CITY PLANNING COMMISSION

APPLICATION: A. Plan Review of 19,977+ square foot automobile sales and service buildings on 3.92+ vacant acres in the General Commercial Review-Executive Airport-4({C-2-R}{EA-4}) zone.

PROPOSAL: The applicant is requesting the necessary entitlements to construct a new car dealership with auto storage, service and display areas.

P-87-372

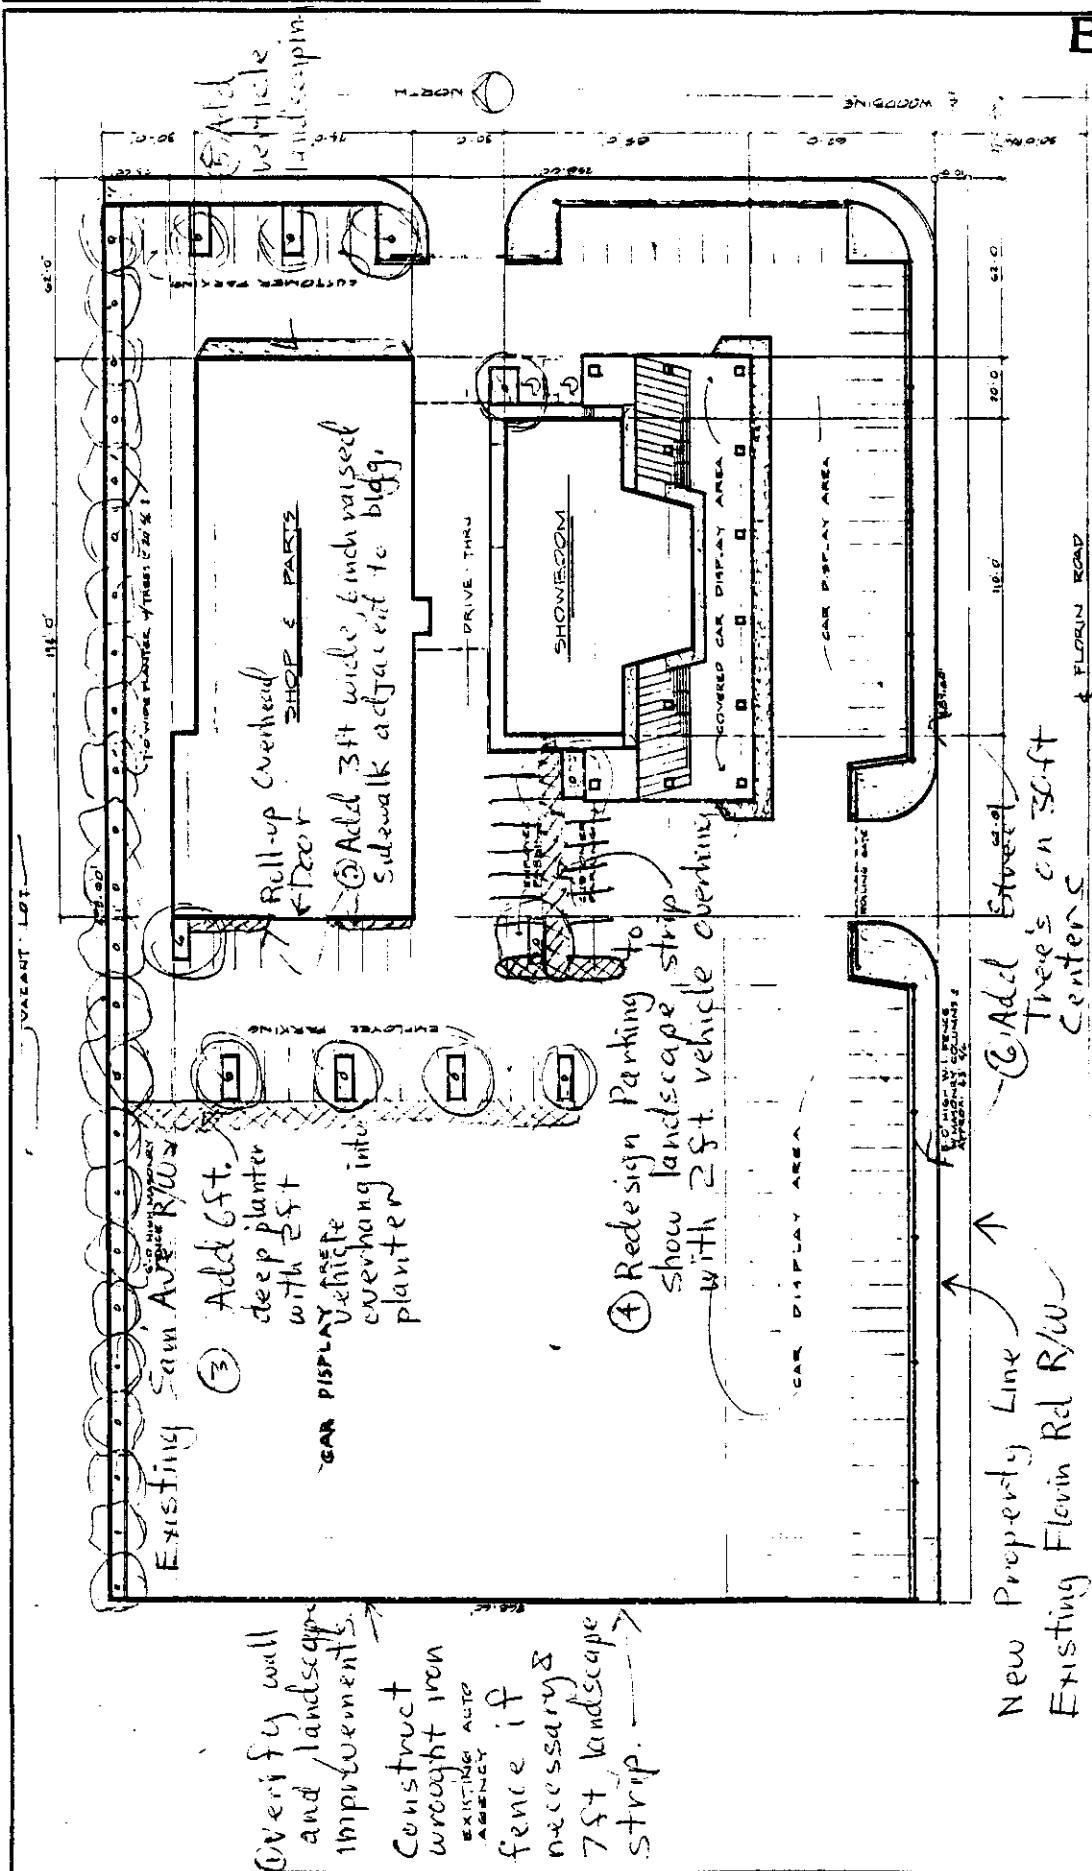
Verify wall and landscape improvements.
 Construct wrought iron EXISTING AUTO AGENCY fence if necessary & 7ft landscape strip.

⑥ No portable concrete wheel stops allowed.

Staff has proposed revisions to the parking lot layout to show use of landscape planters six feet in width to provide both wheel stops and vehicle overhang area. Staff recommends the applicant revise the parking areas as per Exhibit D. Staff modified the site plan to eliminate the use of prefabricated concrete wheel stops and use six inch raised continuous pour concrete curbs adjacent to all planter strips and tree wells.

- a. the addition of landscape planter boxes adjacent to the east wall elevations as shown on Exhibit D as Note 5;
 - b. trees be located adjacent to the public right-of way every 30 feet as a minimum and be a minimum of 15 gallon container size;

ELEVATIONS

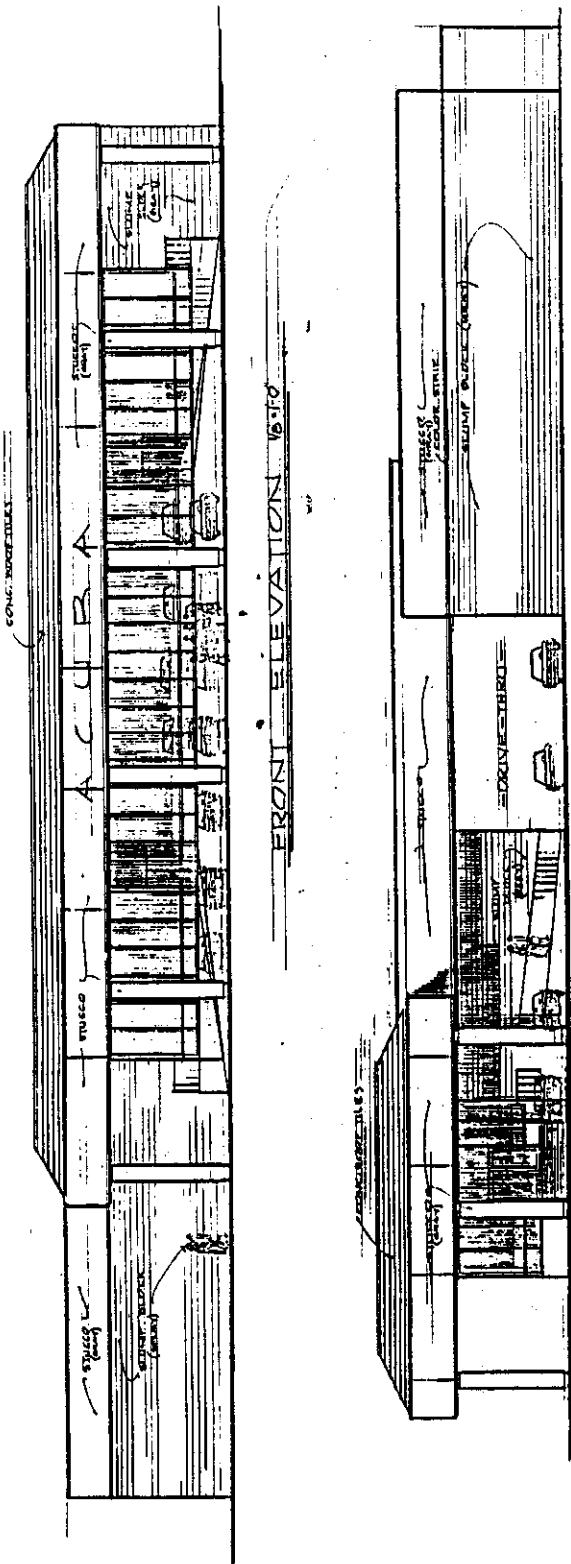
a. The exterior elevations provide a horizontal architectural appearance. Staff has a concern over the relative monotonous style of the east building elevations. In order to provide more relief, staff recommends the addition of several landscape planters adjacent to the building as shown on Exhibit D as noted.

Along the east-facing walls staff suggests planting of vertical climbing vines or shrubbery which break-up the horizontal style of the building wall. Such a modification can be shown on the revised site and landscape plans.
